NEW TRAFFIC SIGNALS CONTRACT 56
CLARENDON AVENUE AND LAGUNA HONDA BOULEVARD TRAFFIC SIGNAL WORK

SPECIFICATION NO.
0761J
DRAWING NO.
E-3.0
FILE NO.
84,258
REV. NO.
2

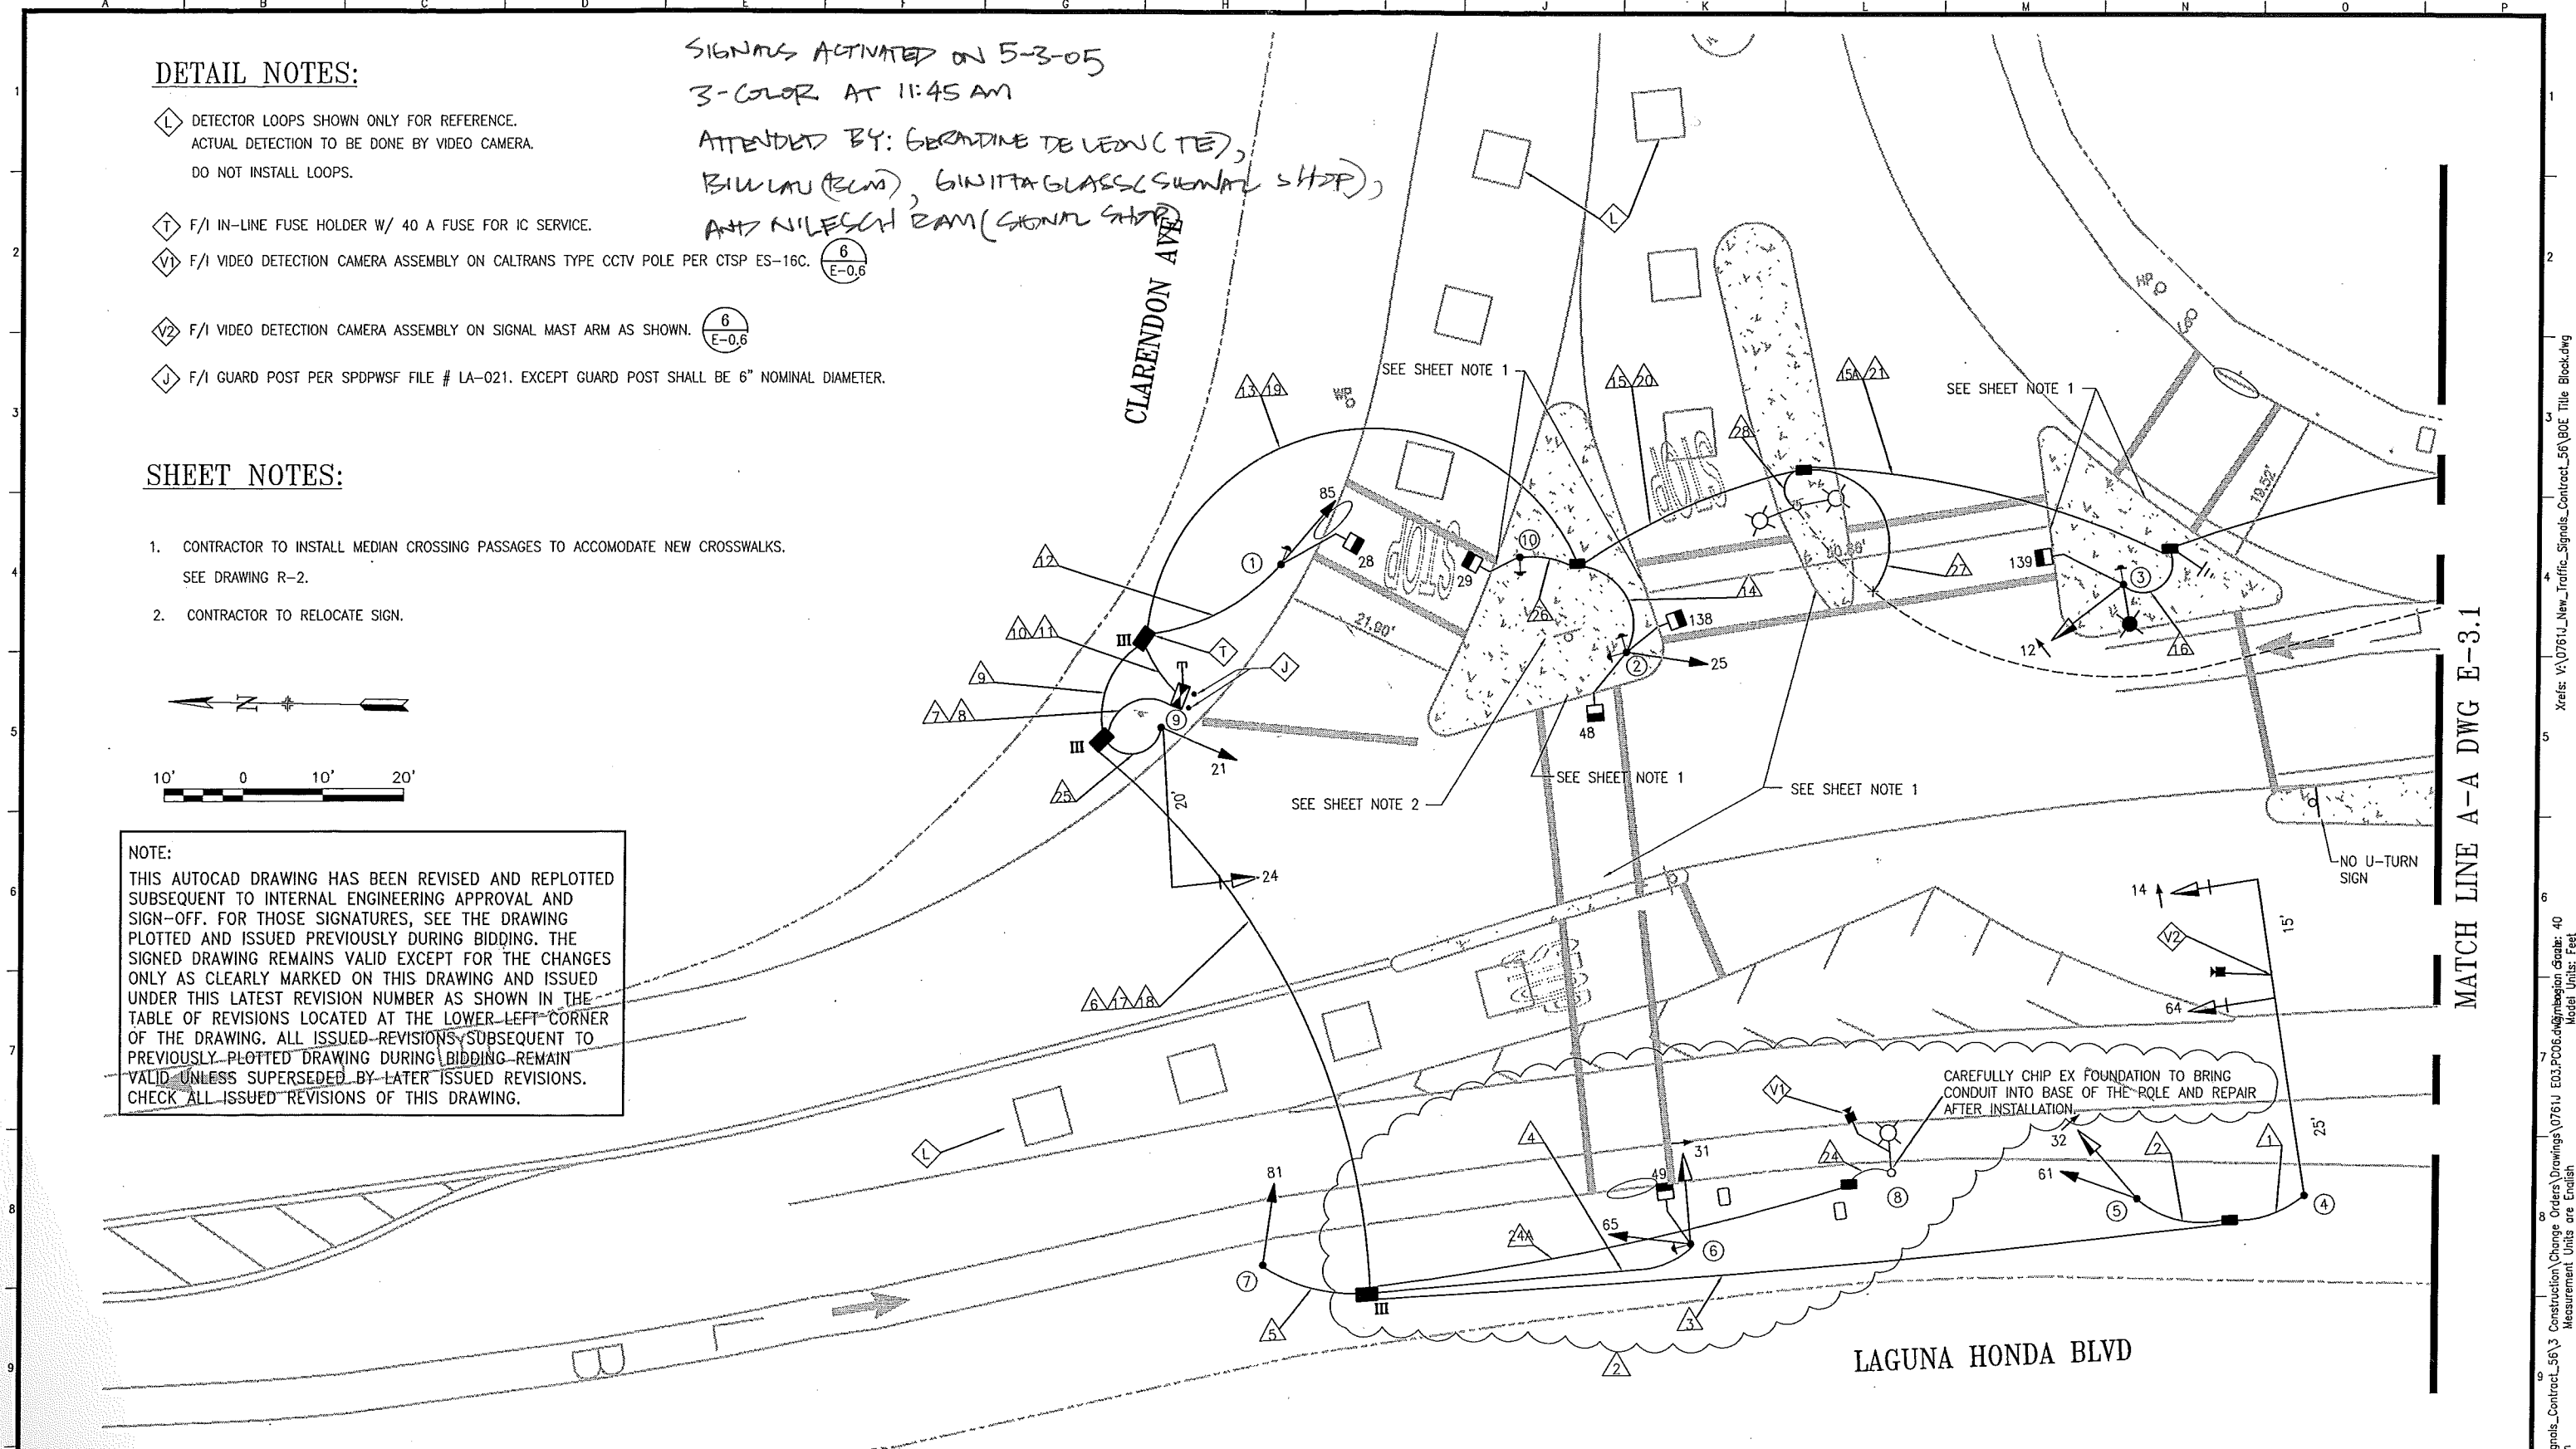
NO.	DATE	DESCRIPTION	BY	APP.
2	04/05	RELOCATE VIDEO CAMERA TO EX SL	BC	
1	10/04	ADD BOLLARDS & RELOCATE POLE #10	RP	BC
0	01/04	ISSUED FOR BID

SPECIFICATION NO.
0761J
DRAWING NO.
E-3.1
FILE NO.
84,259
REV. NO.
1

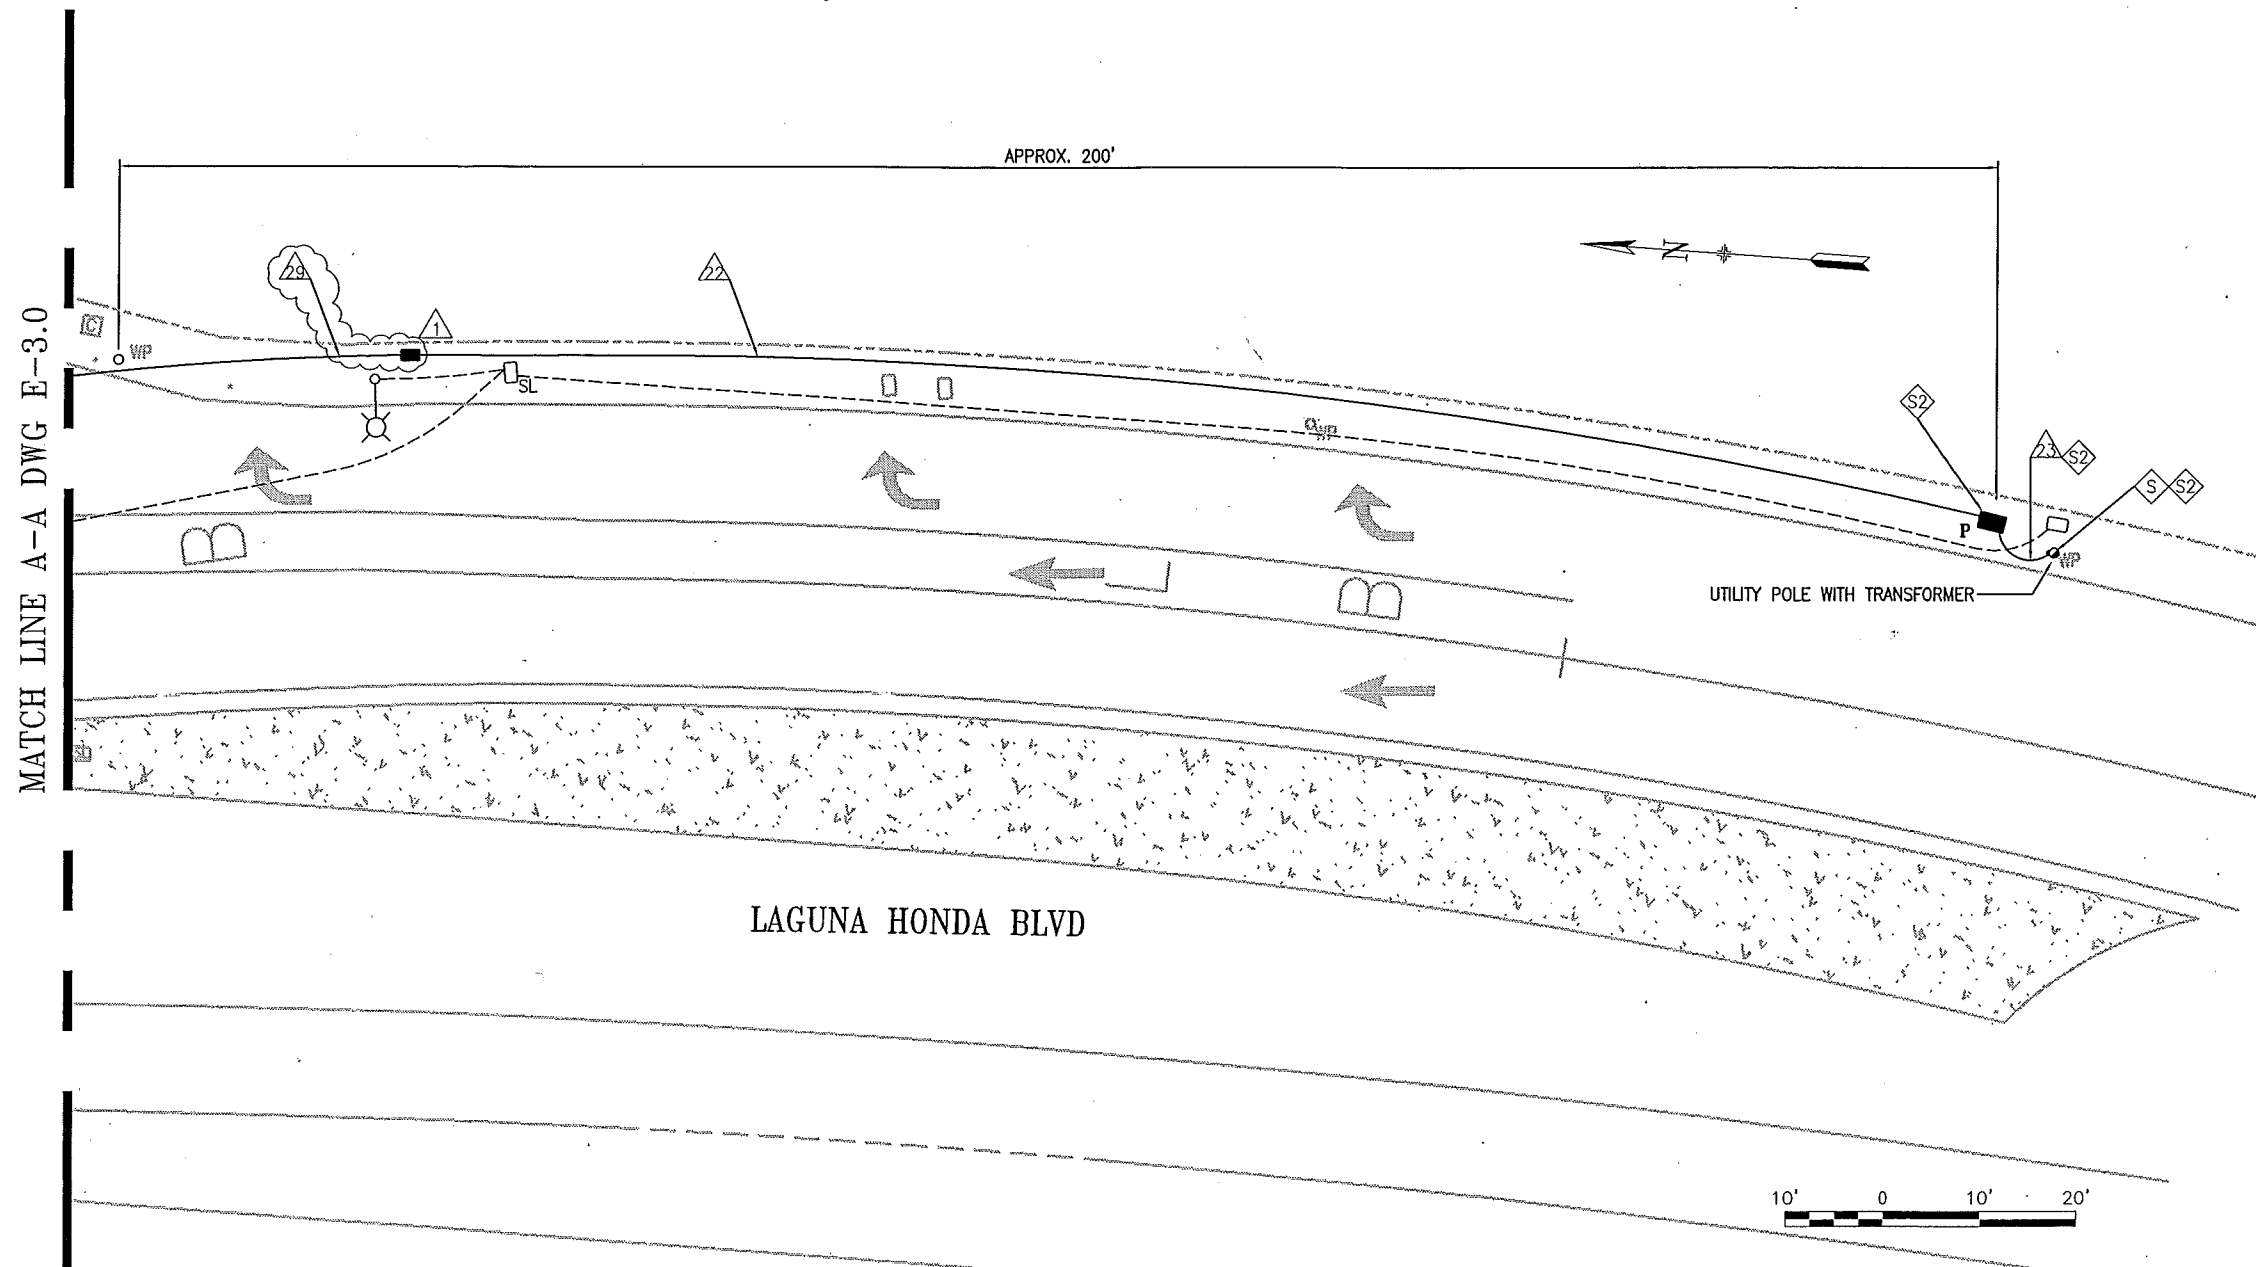
NO.	DATE	DESCRIPTION	BY	APP.
1	10/04	ADD TYPE I PULL BOX	RP	BC
0	01/04	ISSUED FOR BID
